Our ref:
MS/6364/OCCLLFAR/

Planning Ref: DC/21/2571/VOC

Location: Jacobs Douwe Edberts, Ruscote Avenue, Banbury,

PRP Responses in RED

Title:
**Impermeable Area
& Overland Flow Arrows**

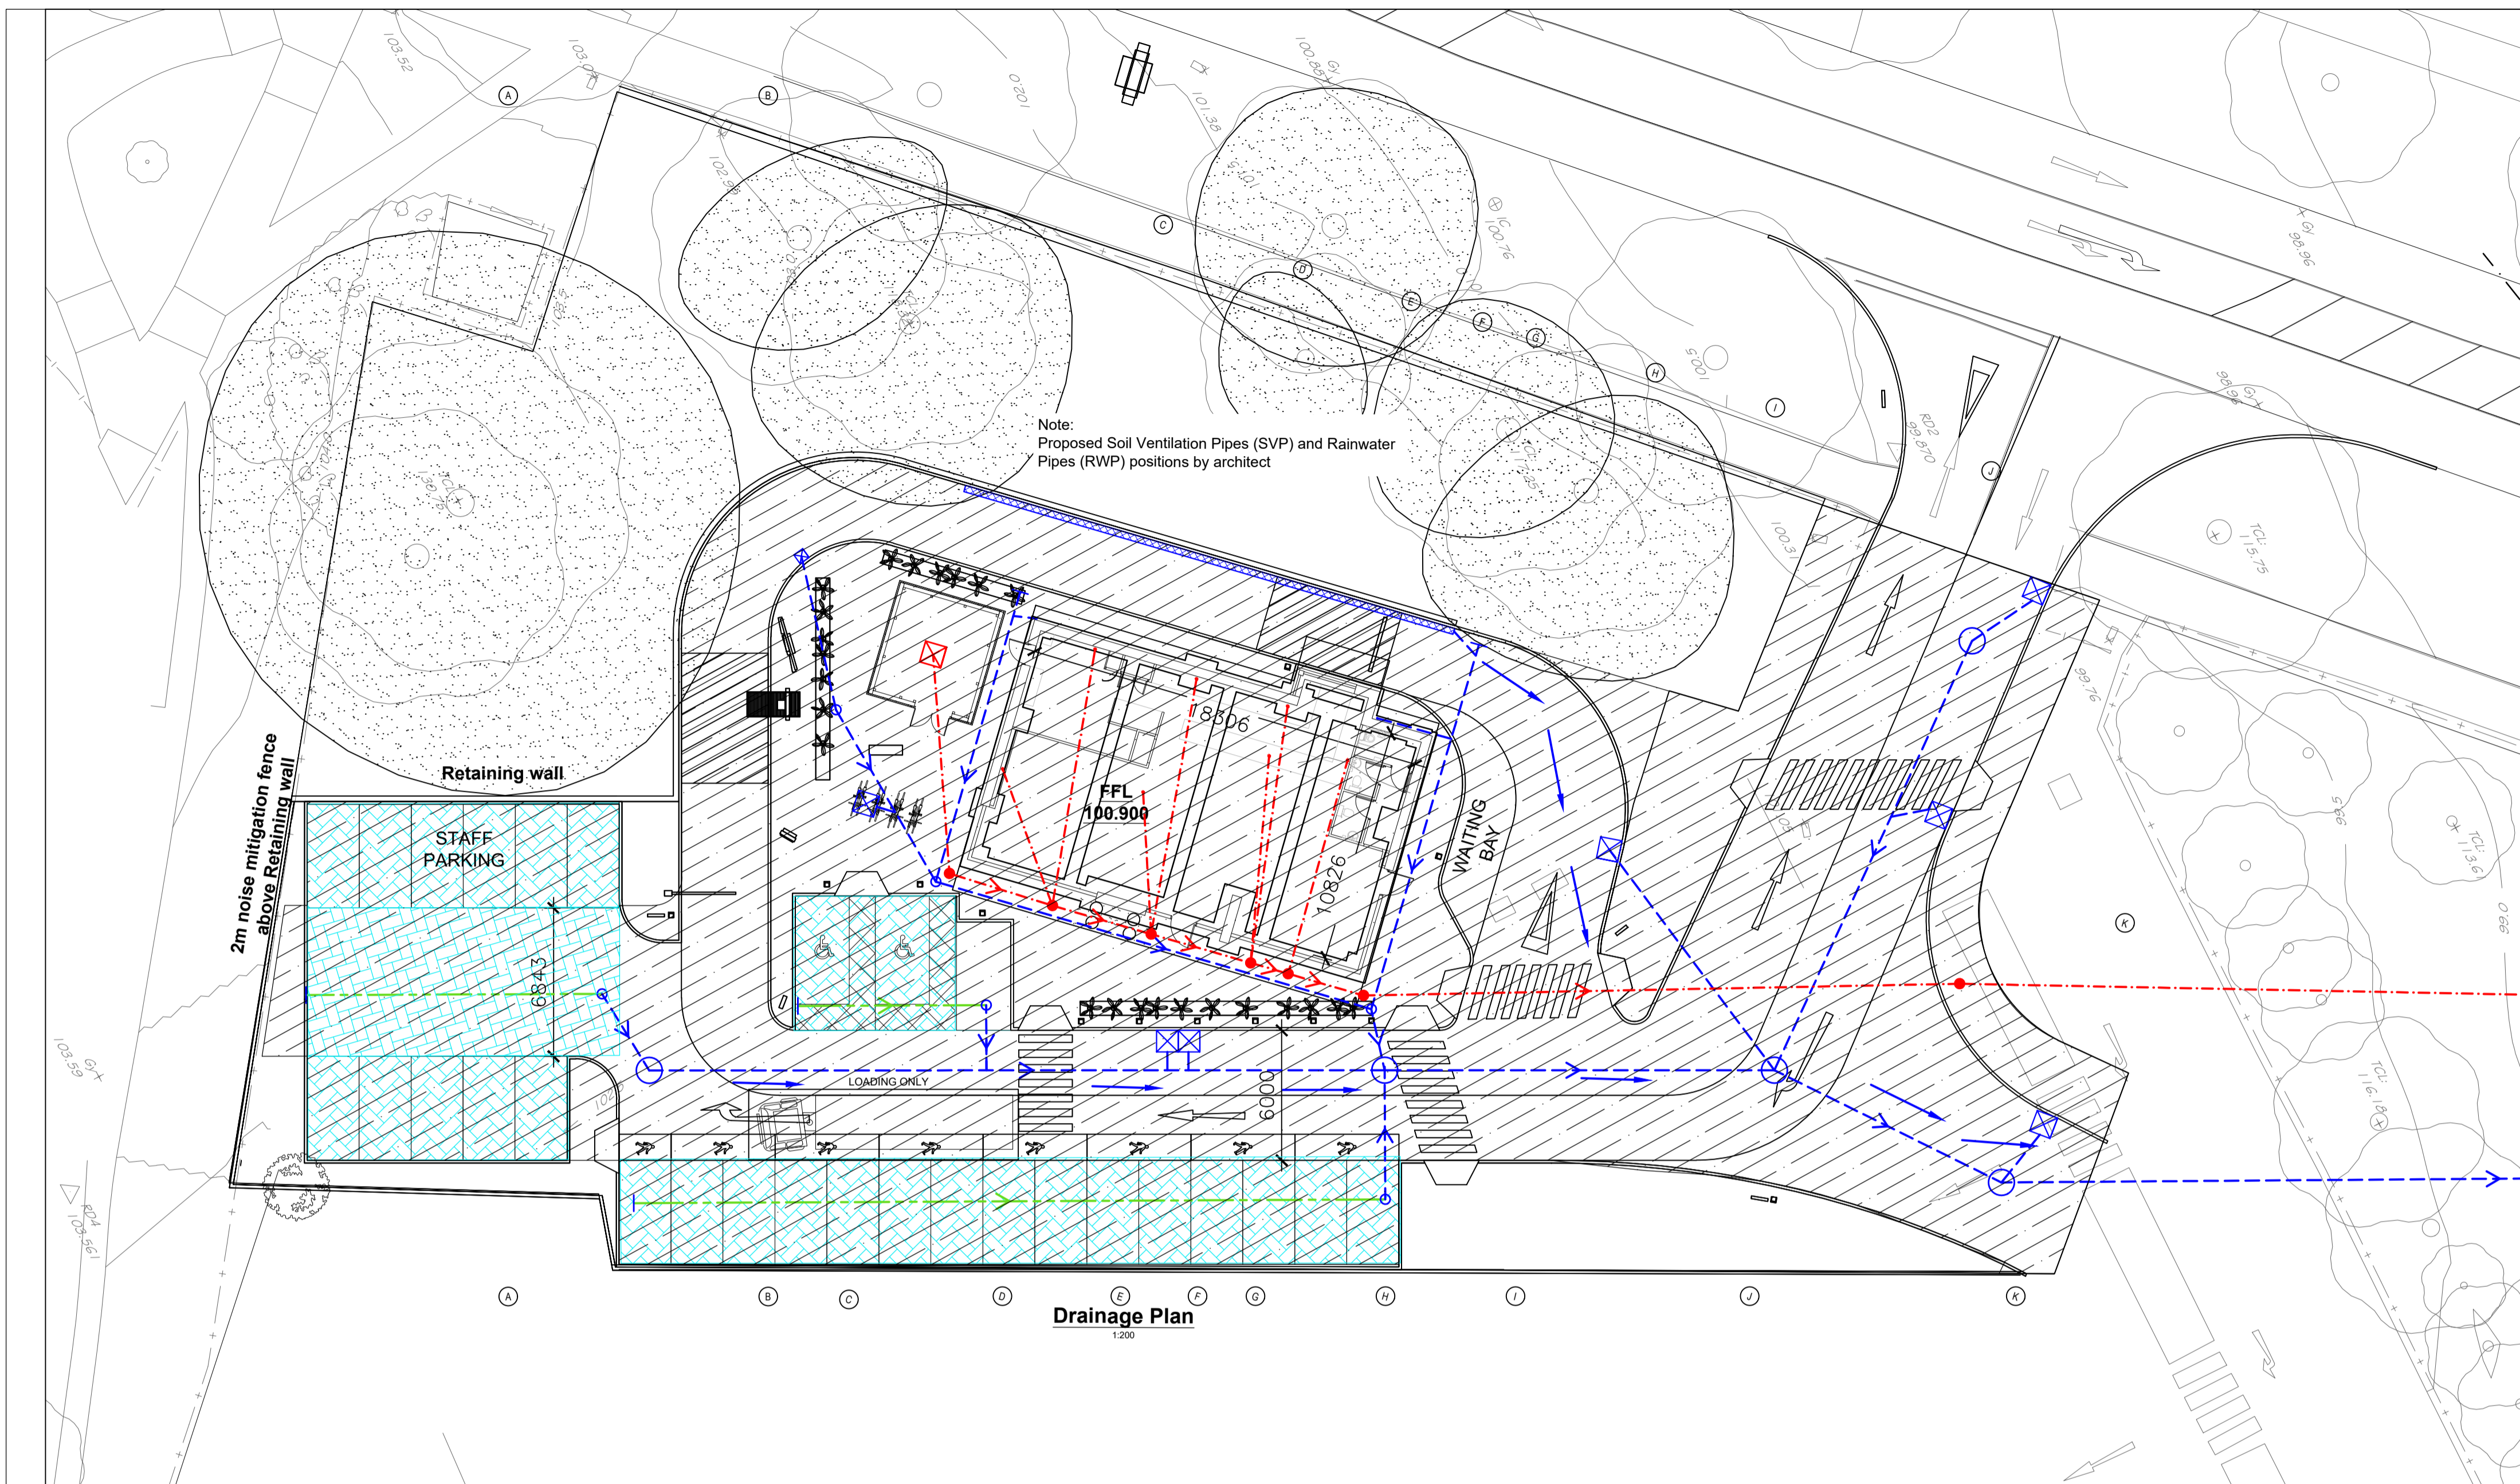
Impermeable area plan needs to be provided to show the extent of the areas and stating the area. The plan should demonstrate clearly where the area will be draining to. – Plan appended

Surface water exceedance plan to be provided to demonstrate all surface water will be kept away from structures and within the site boundary in an event where the surface water network fails. – Plan appended
